RBG-45936

Subject: River Bend Station
Docket No. 50-458
License No. NPF-47
License Amendment Request (LAR) 2002-08, "Division 1, 2, and 3 Degraded Voltage Setpoint Revision due to Updated Calculations and Installation of Improved Relays"

Analysis of Proposed Technical Specification Change

RBS Simplified One-Line

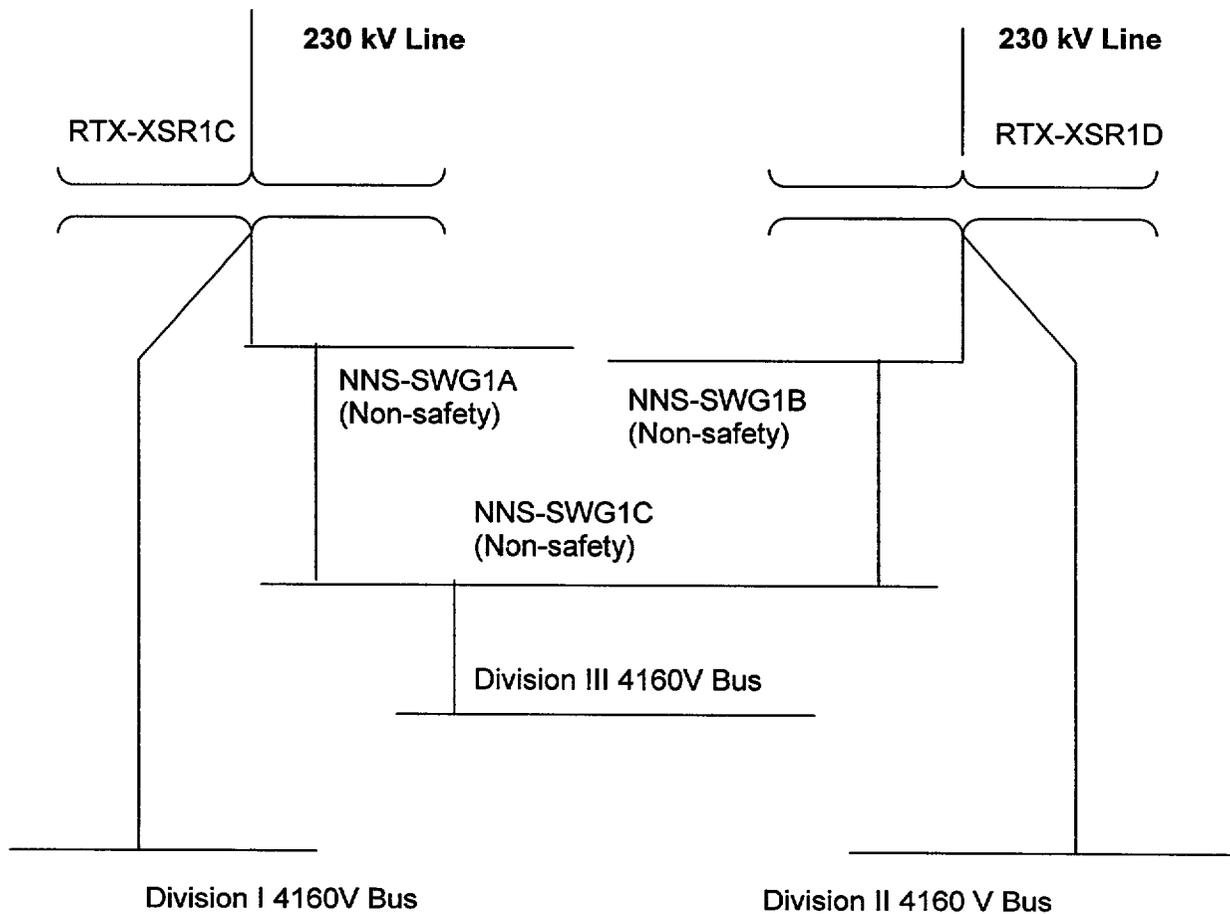
The River Bend Station Division 1 4160 V safety related bus is fed directly from preferred transformer RTX-XSR1C and the Division 2 4160 V safety related bus is fed directly from preferred transformer RTX-XSR1D. A non-safety 4160 V bus is also fed from each of these preferred transformers. In turn, a third non-safety 4160 V bus can be fed from either of the upstream non-safety 4160 V buses. See Simplified One-Line Diagram below:
